SIBLING
ARCHITECTURE

OLD BEGA HOSPITAL
ARTS & CULTURAL CENTRE

DESIGN DEVELOPMENT 03
30.04.2018

1. REVIEW OF FEEDBACK ITEMS

VIEW FROM SOUTH - EAST GUTTER DIAGRAM

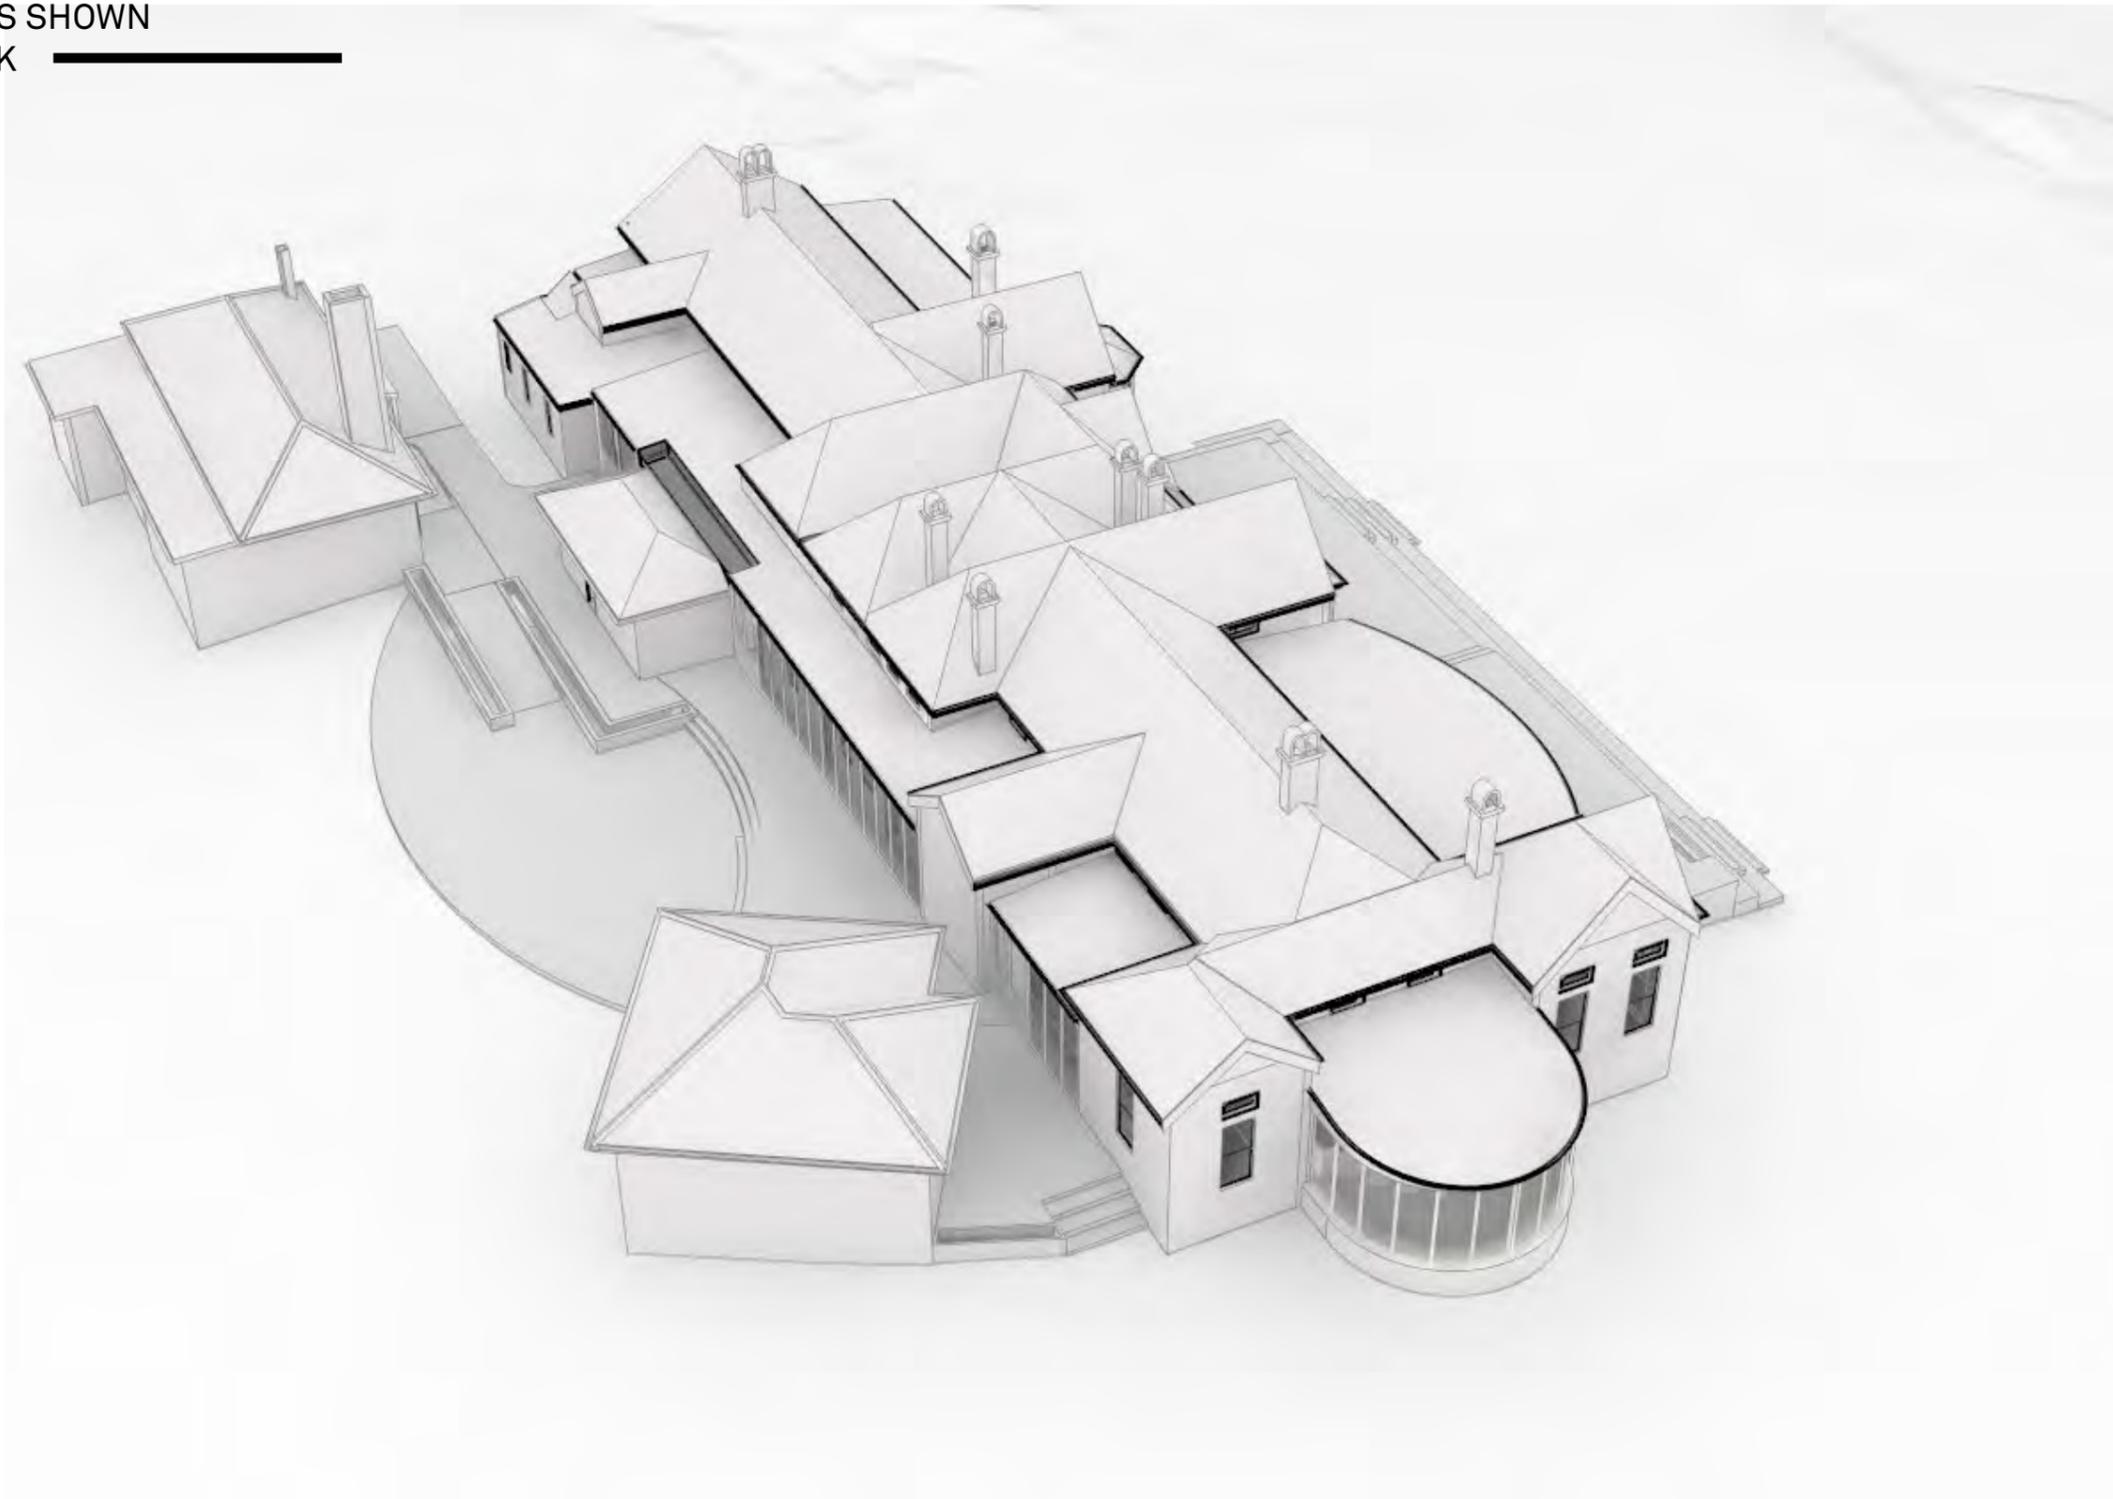
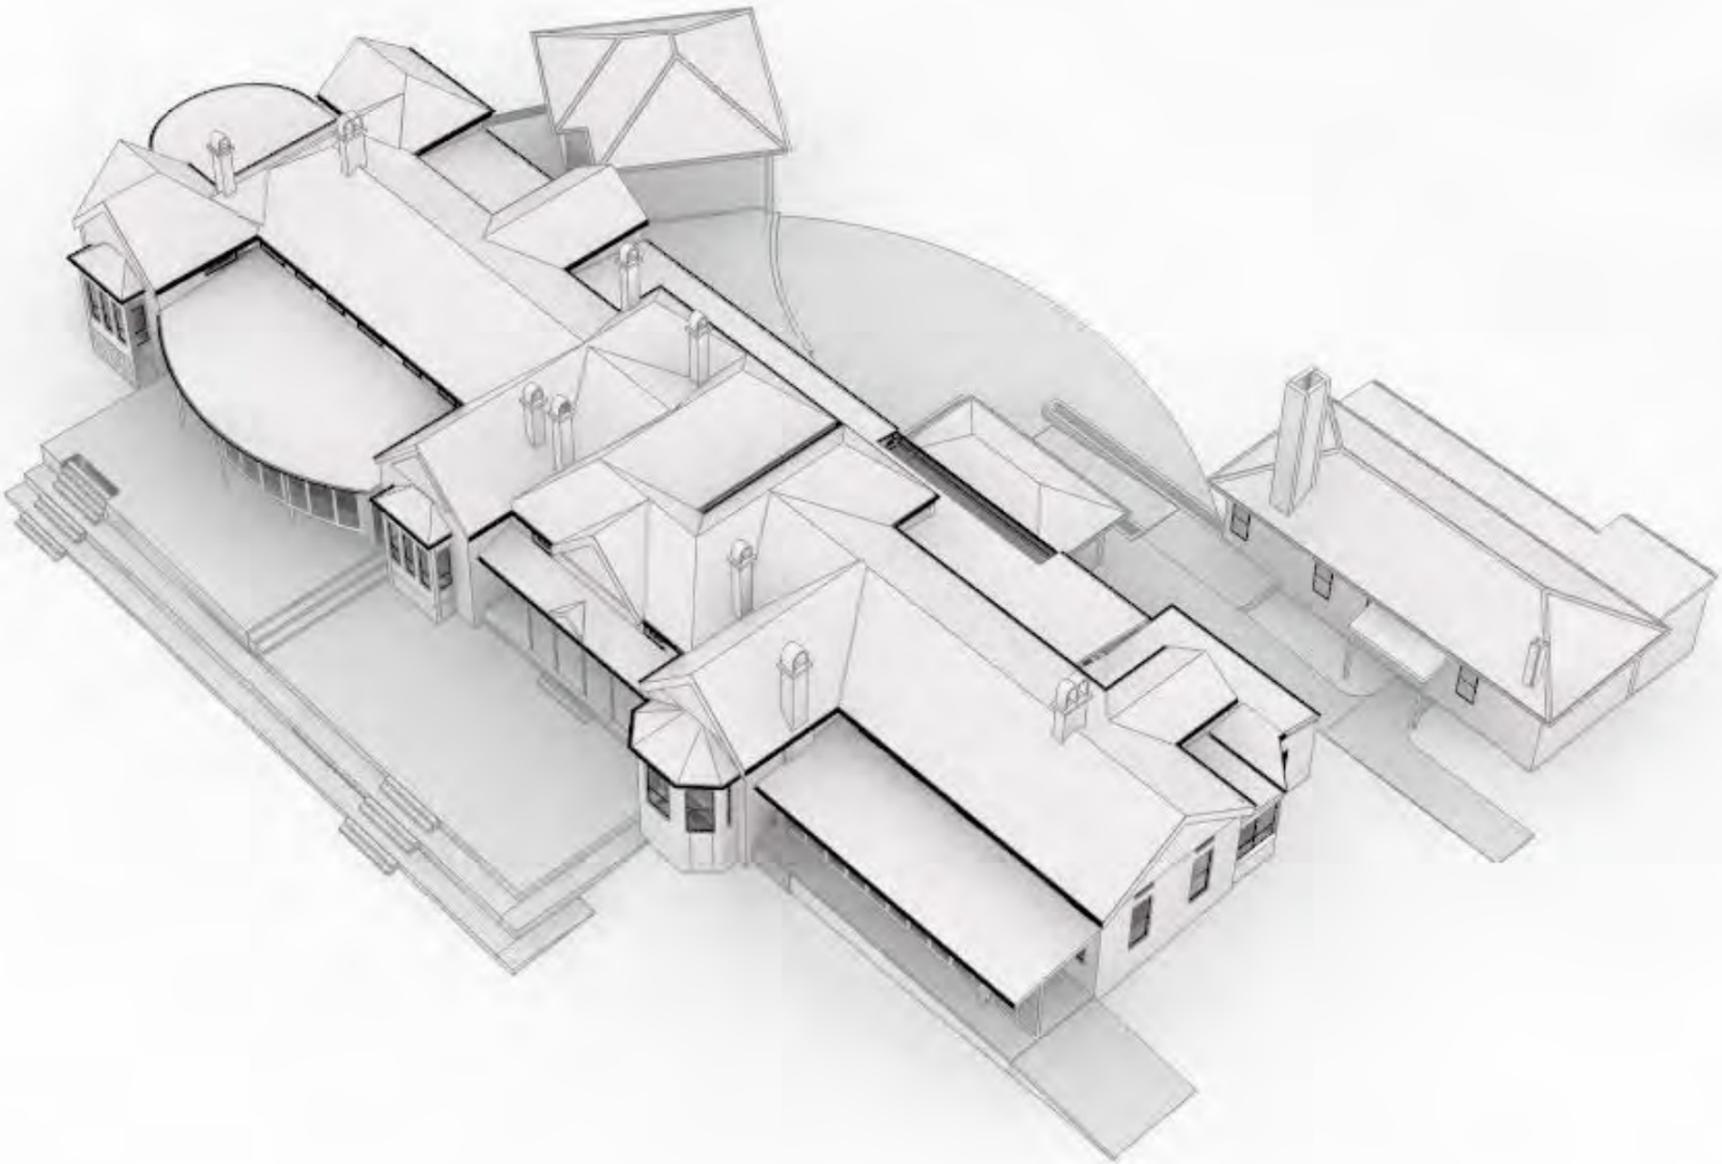
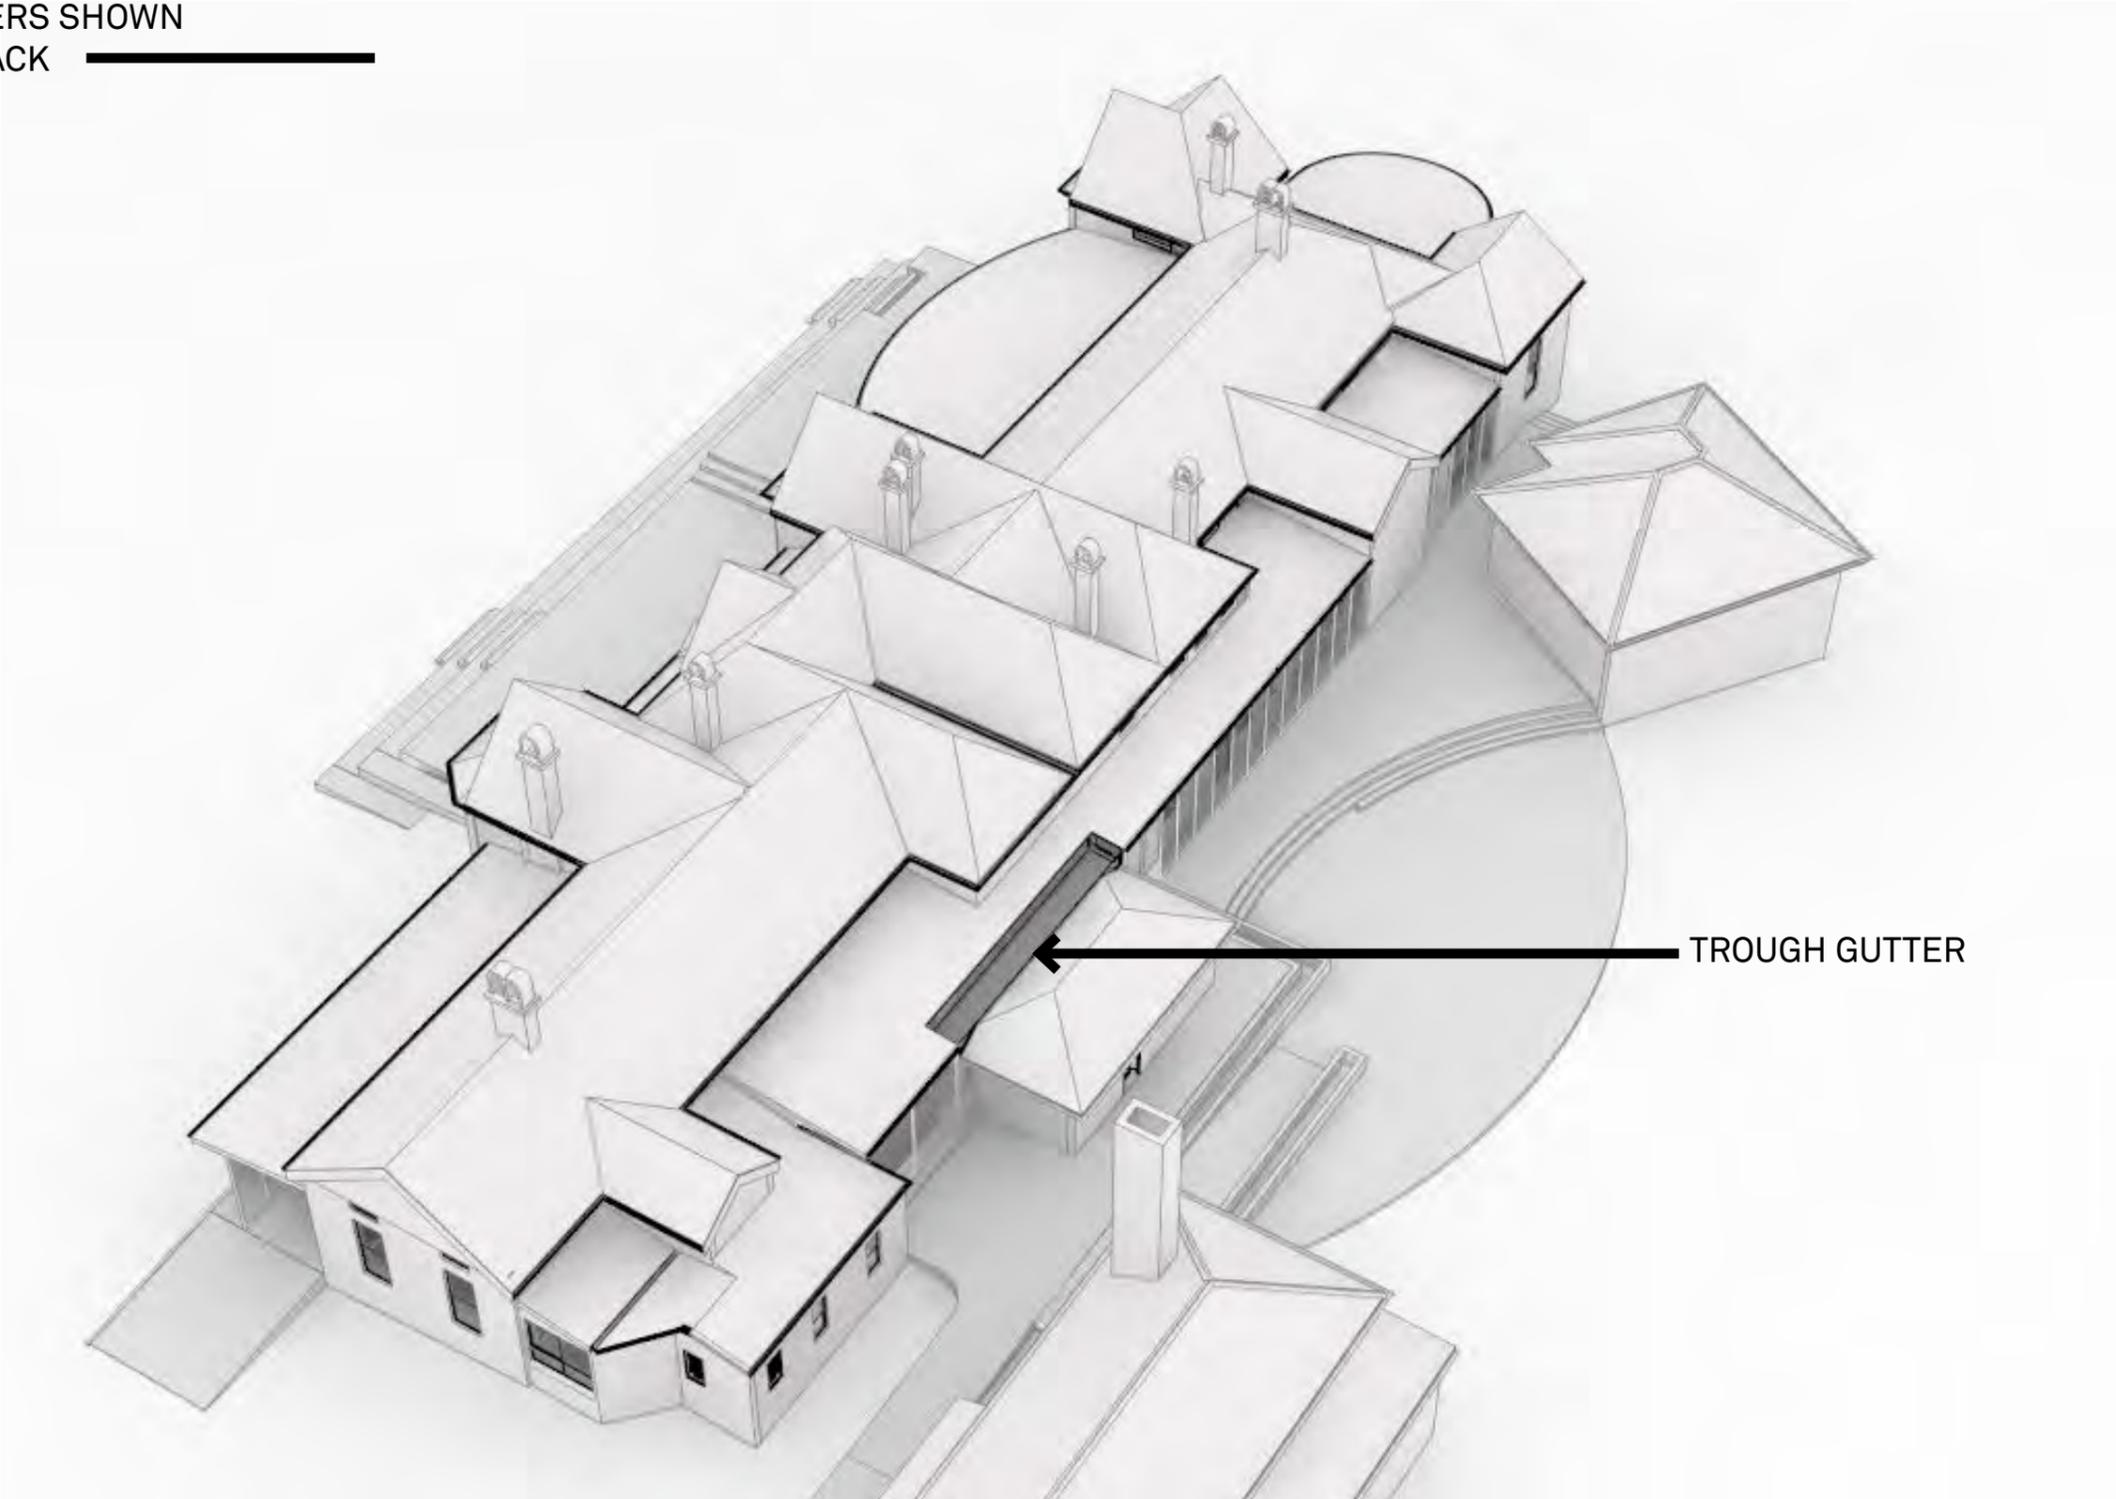
7. ROOF DRAINAGE. SEEMS THAT IS UNDER CONTROL, 3D IMAGE TO COME, INCLUDING "TROUGH" ARRANGEMENT BETWEEN SOUTHERN VERANDA AND THE MORGUE- SEE FOLLOWING PAGES FOR DRAINAGE DIAGRAMS

GUTTERS SHOWN
IN BLACK
